UNITED STATES  
NUCLEAR REGULATORY COMMISSION  
WASHINGTON, D.C. 20555-0001

SUBJECT: FORT CALHOUN STATION, UNIT 1 – ISSUANCE OF AMENDMENT RE:  
REVISED TECHNICAL SPECIFICATIONS TO ALIGN TO THOSE  
REQUIREMENTS FOR DECOMMISSIONING (CAC NO. MF9567;  
EPID L-2017-LLA-0192)

Amendment No. 297  
Renewed License No. DPR-40

FIGURE 2-10

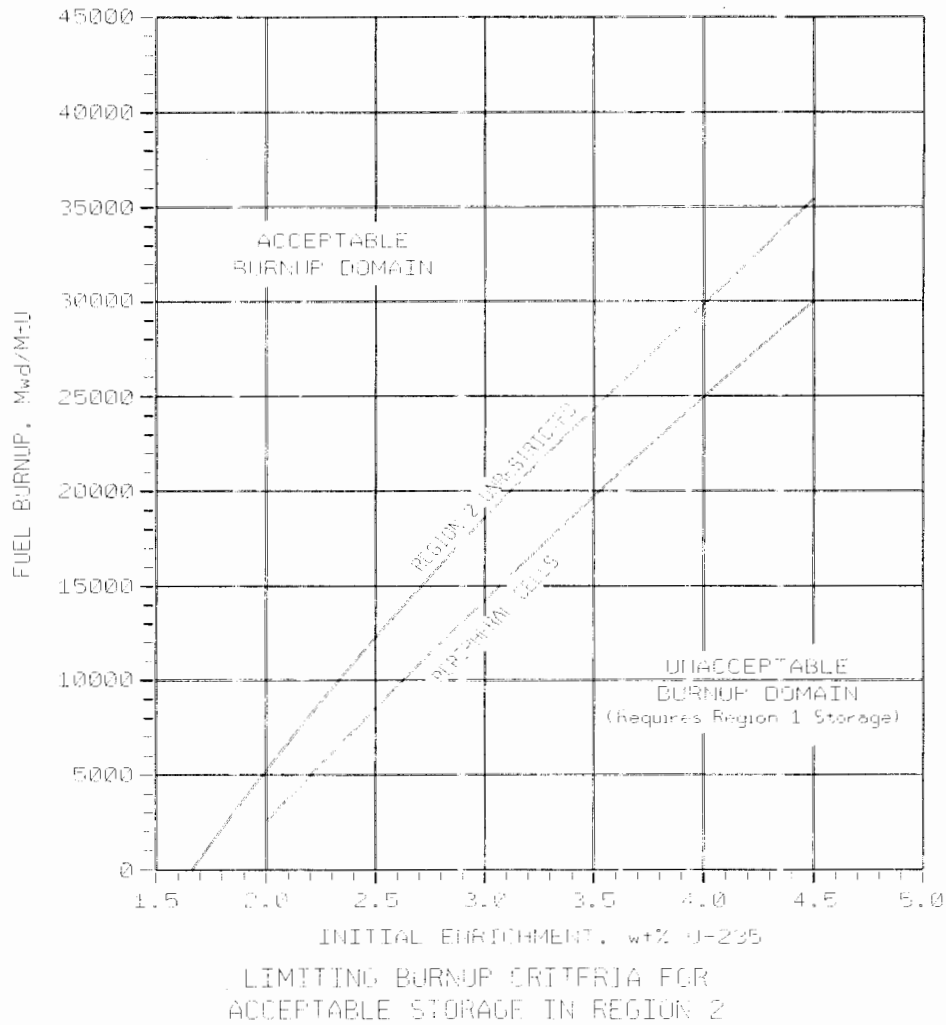
The combination of initial enrichment and burnup of each spent fuel assembly stored in Region 2 (including peripheral cells) of the spent fuel pool shall be within the acceptable burnup domain of Figure 2-10.

- e. Partially spent fuel assemblies with a discharge burnup in the "acceptable domain" of Figure 2-10 for "Region 2 Unrestricted" may be allowed unrestricted storage in any of the Region 2 fuel storage racks in compliance with Reference (1).

- f. Partially spent fuel assemblies with a discharge burnup between the "acceptable domain" and "Peripheral Cells" of Figure 2-10 may be allowed unrestricted storage in the peripheral cells of the Region 2 fuel storage racks in compliance with Reference (1).

- g. Partially spent fuel assemblies with a discharge burnup in the "unacceptable domain" of Figure 2-10 will be stored in Region 1 in compliance with Reference (1).
